September 15, 2014

Re: The City of Benicia's Draft Environmental Impact Report for the
Valero Benicia Crude by Rail Project

Figure 1: Reid Vapor Pressure Compared to Total Sulfur and Density for 76 different types of Crude Oil

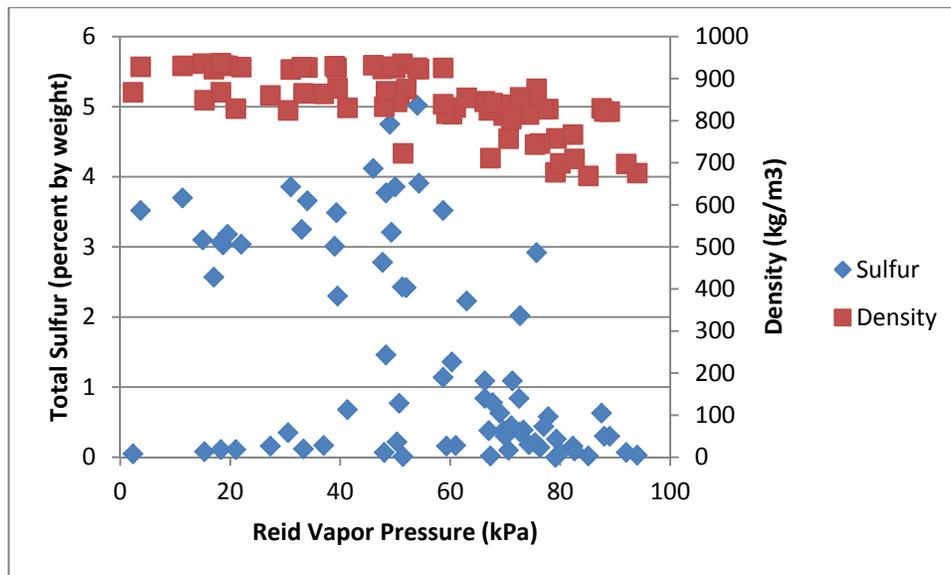
Further, other characteristics, such as vapor pressure or flammability, differ in significant ways among crudes with similar sulfur and weight. The DEIR actually concedes that there is no relationship between vapor pressure (expressed as RVP) and weight (expressed as API) for different crude types. DEIR, Appx. K at K-18. This is further substantiated by analysis of data published by Enbridge, summarized here in Figure 1. The Enbridge data covering 76 different types of crude oil show that crude oil attributes of sulfur content and density are completely independent of vapor pressure. Fox DEIR Comments at 4.

The vapor pressure of crude determines to a large extent the amount of reactive organic gases (ROG) and toxic air contaminants (TAC) that are emitted when the crude is transported, stored, and refined. Thus, a crude slate may have identical sulfur content and weight, but dramatically different ROG and TAC emissions.
